**CITY OF DELRAY BEACH  
CHANGE ORDER TO ORIGINAL CONTRACT**

CHANGE ORDER NO. 1

PROJECT NO. 16-030

PROJECT TITLE: Master Lift Station #1 Rehabilitation

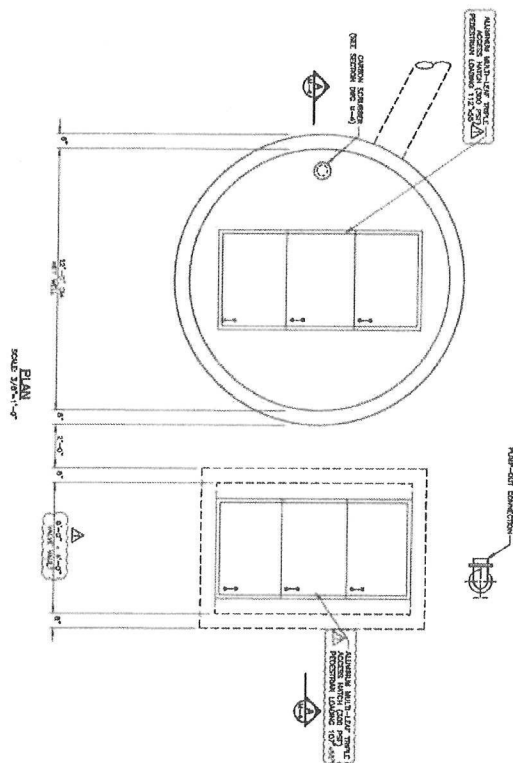
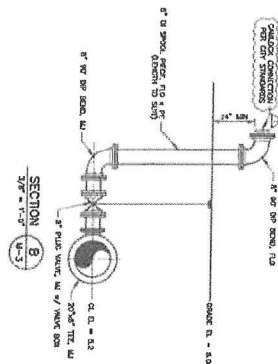
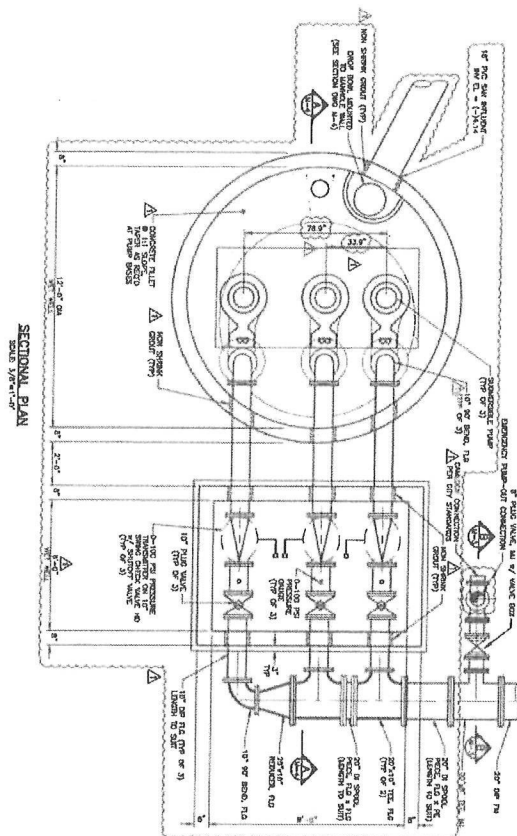
Item No. 3 – Valve Vault size, Manifold Piping & Hatches. \$10,807.72 (Rev 1, Sheets C3, C4, M3, M4)

Due to the unusually large diameter of the Force Main Manifold piping, the piping had to be located outside of the Valve Vault. City standard details using mechanical joints could not be used because of the size of the manifold fittings. Flanged fittings (that cost more) were used in lieu of mechanical fittings to keep the manifold as compact as possible. The Valve Vault size was increased slightly and the hatches were adjusted to provide more room for increased pipe spacing due to these large fittings.

**DESCRIPTION:** Added cost for valve vault and force main  
manifold adjustments. (plan revision)
